PLANNING COMMISSION AMENDED MEETING AGENDA

Wednesday, April 10, 2024

1. Actions of the Zoning Administrator
2. **P24-0110, Nora Collins, 5675 Owens Drive (parent address 4452 Rosewood Drive)** - Application for a Conditional Use Permit to operate a childcare facility for a maximum of 110 children and 18 staff members at the facility at one time in an approved yet constructed building to be located at the northeast corner of Rosewood and Owens Drives.
3. Approve the minutes of March 27, 2024

5. **P23-0599, Kelley Rutchena, 5976 & 5994 West Las Positas Boulevard** - Application for Design Review and a Vesting Tentative Map for a housing development that includes the demolition of two existing commercial buildings and construction of 146 multi-family residential units with 38 accessory dwelling units with associated site improvements located at 5976 & 5994 West Las Positas Boulevard

VESTING TENTATIVE MAP
FOR CONDOMINIUM PURPOSES
COVER SHEET
5976 W. LAS POSITAS BLVD.

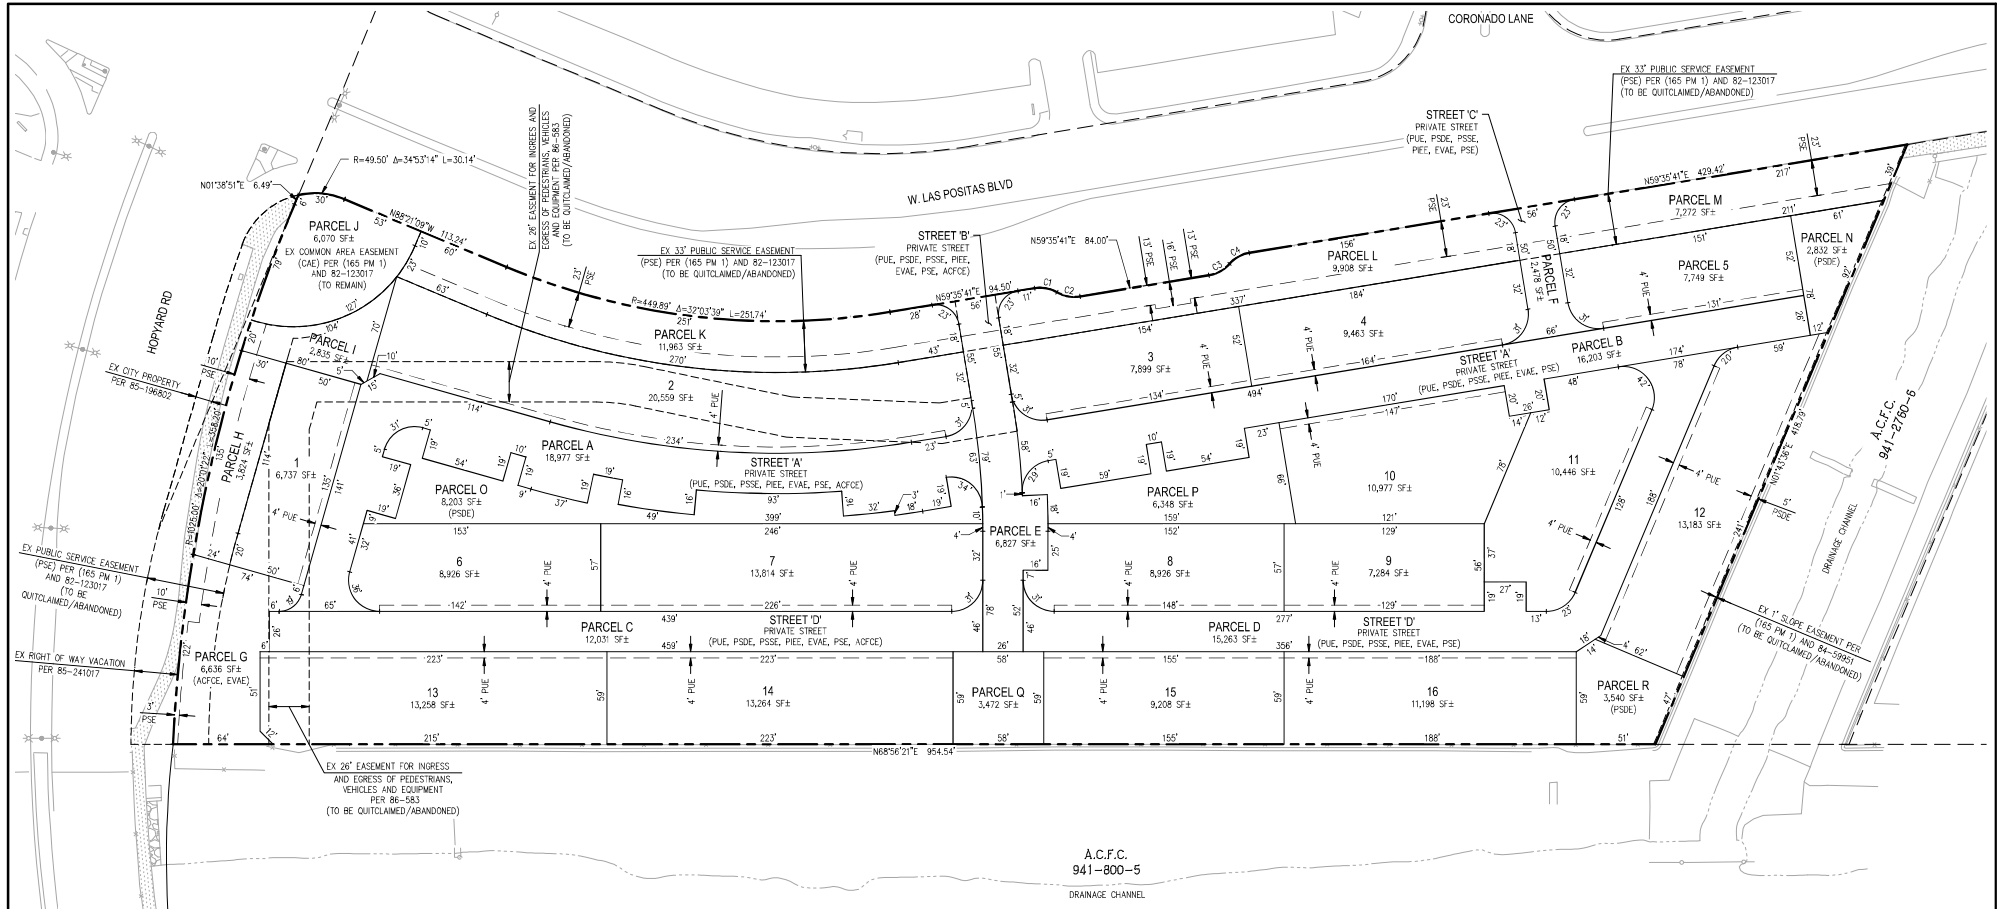
78. ODS A1.4, requires internal sidewalks to be a minimum of 5' wide and sidewalks within paseos to be a minimum of 6' wide. Sidewalks shown on VTM sheet C10 and Civil sheet C2 show 4' sidewalks, which does not meet ODS standards.
79. ODS A1.5 requires developments adjacent to public trails to provide access for residents. The plans do not show this ODS standard.
80. The traffic analysis provided by the consultant does not appropriately analyze VMT. To be consistent with the HE the VMT used shall be the Alameda County average per resident which is 17.6. The threshold for the project is then 85 percent of that, or 15.0.

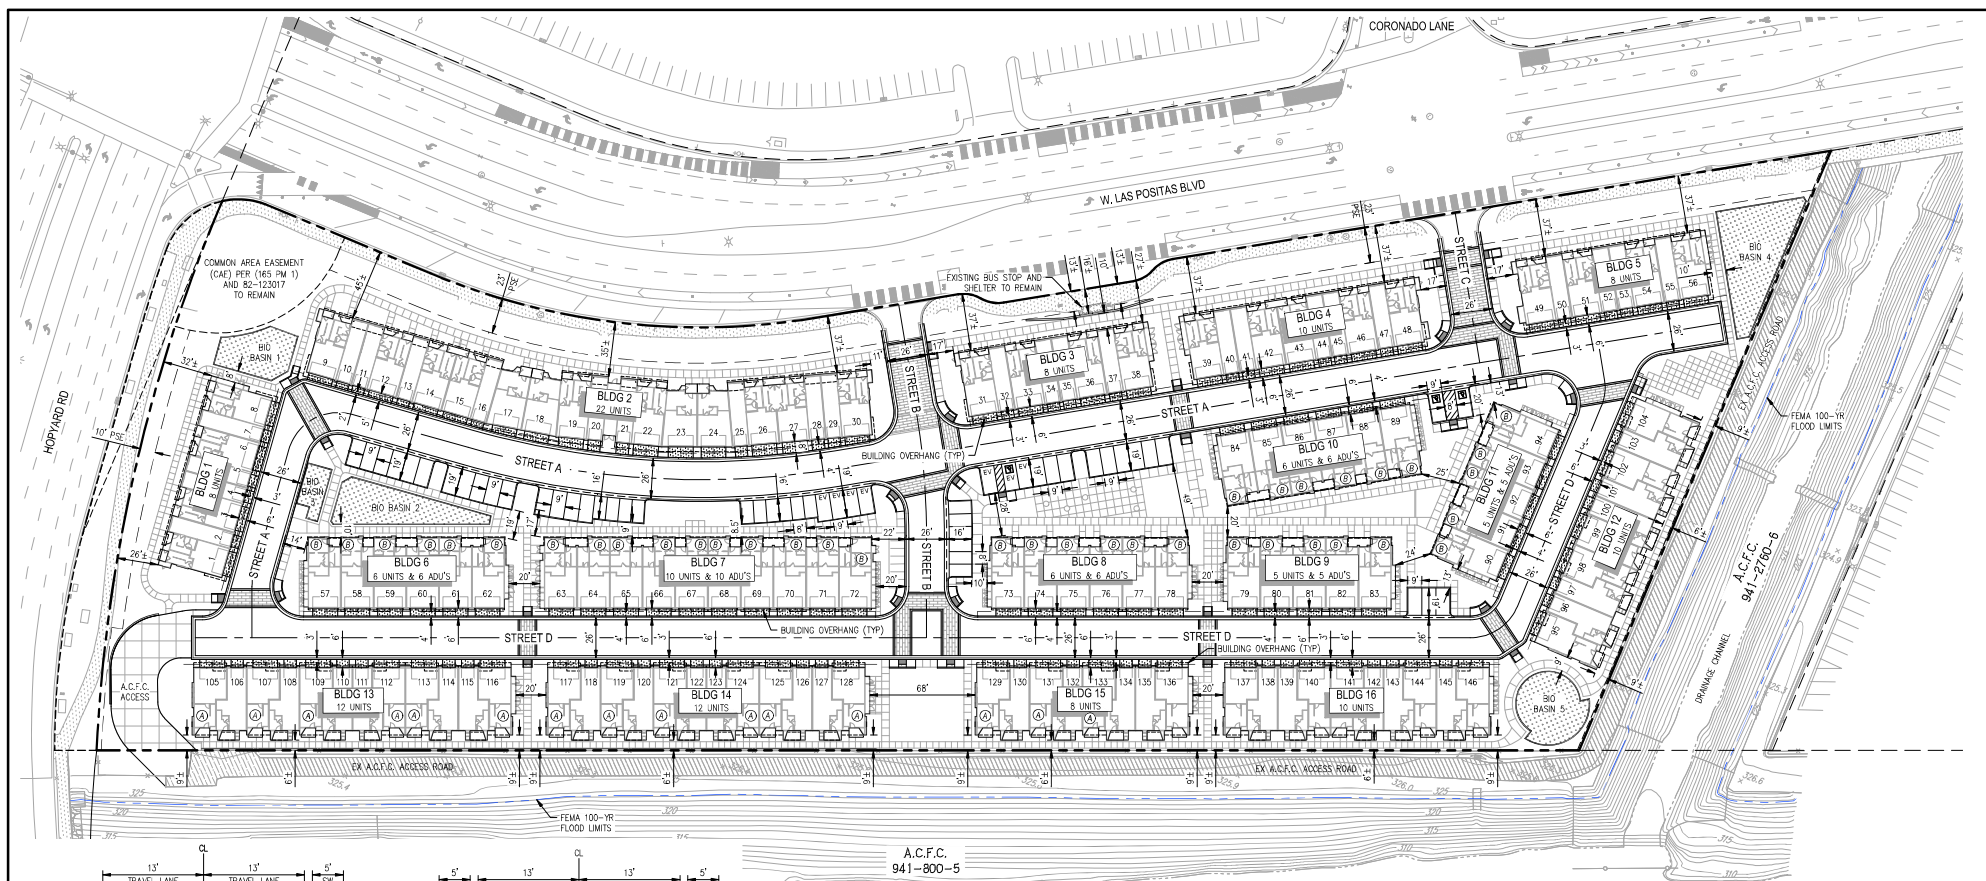
- b) Exception 6 refers to a Slope Easement granted to Alameda County Flood Control and Water Conservation District recorded as 84-059951 on 3-28-1984. Notes on Sheets C2 and C3 of the Vesting Tentative Map indicate that this easement will be quitclaimed/abandoned. The applicant shall provide evidence that ACFC&WCD has agreed to relinquish rights across their slope easement. Otherwise, the notes shall be removed.

- c) Exception 8 refers to an Access Easement granted to Alameda County Flood Control and Water Conservation District recorded as 86-000583 on 1-02-1986. Although this easement is shown on Sheets C2 and C3 of the Vesting Tentative Map, it nonetheless conflicts with proposed buildings on Parcels 1, 2, and 13. The District will need to vacate this easement in order for these buildings to be constructed, and will likely request equivalent access through the developed property. Although the applicant submitted documentation of discussion with District staff, the applicant shall provide evidence that ACFC&WCD has agreed to relinquish rights across conflicting portions of their access easement. In the absence of this evidence, the development cannot be constructed as proposed.

SHEET NO.
C5
OF 10 SHEETS

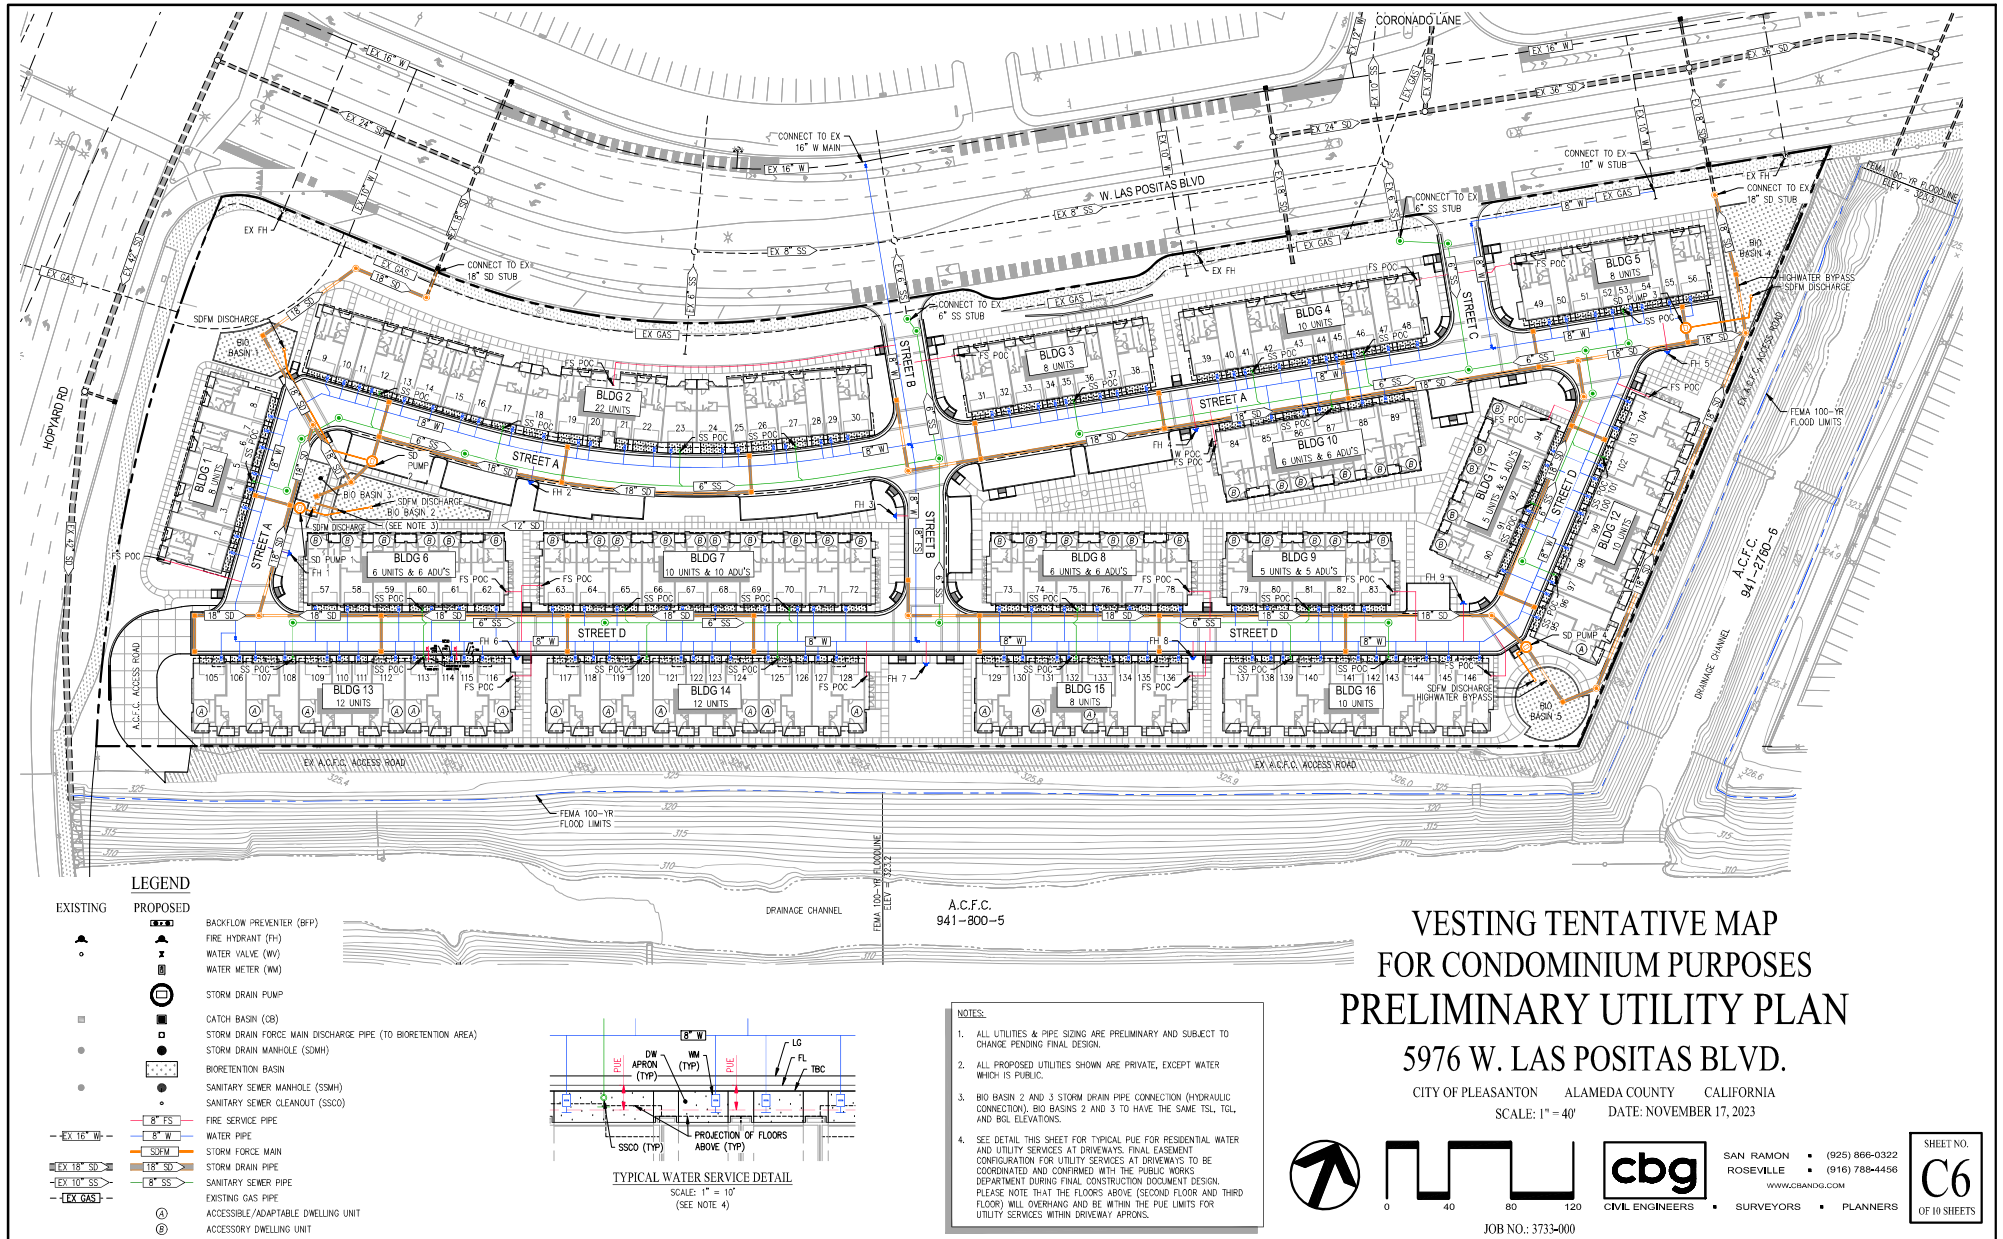
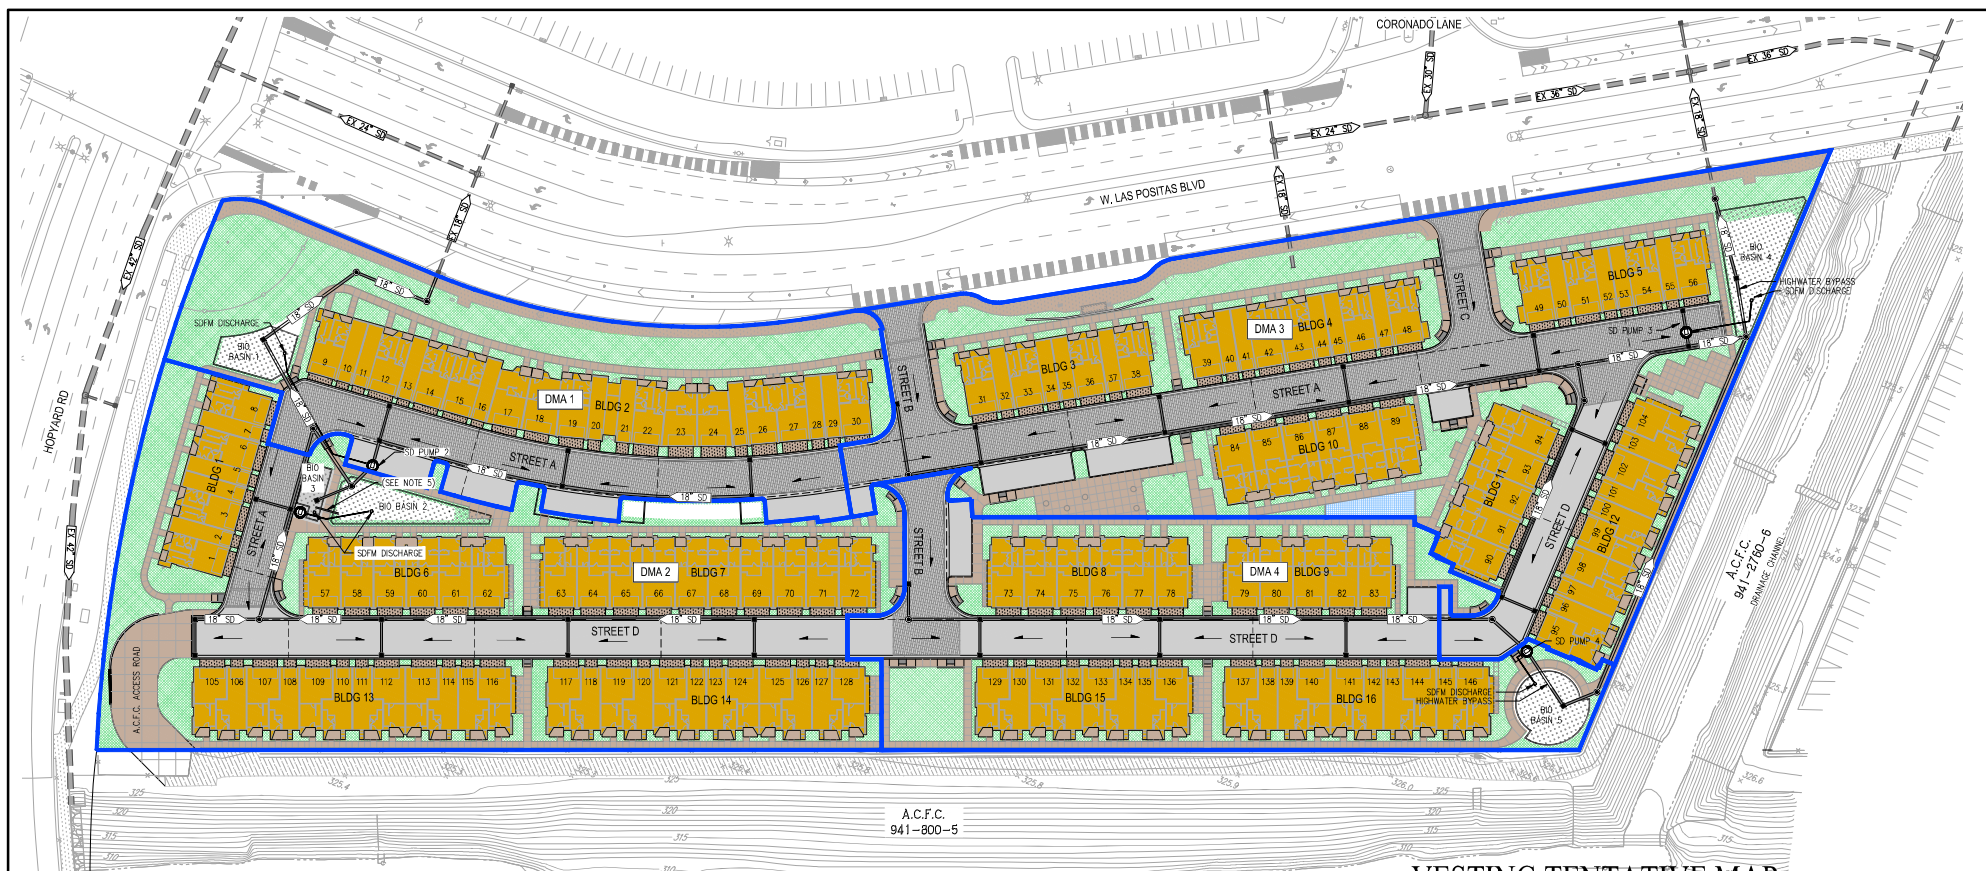
Referring to Sheet C5 of the Vesting Tentative Map, the proposed ACFC access will drain directly to the adjoining flood control channel without treatment, not DMA 2 as suggested on Sheet C7. The Program requires stormwater runoff from all areas of the site be treated. The design shall be revised to address this issue.
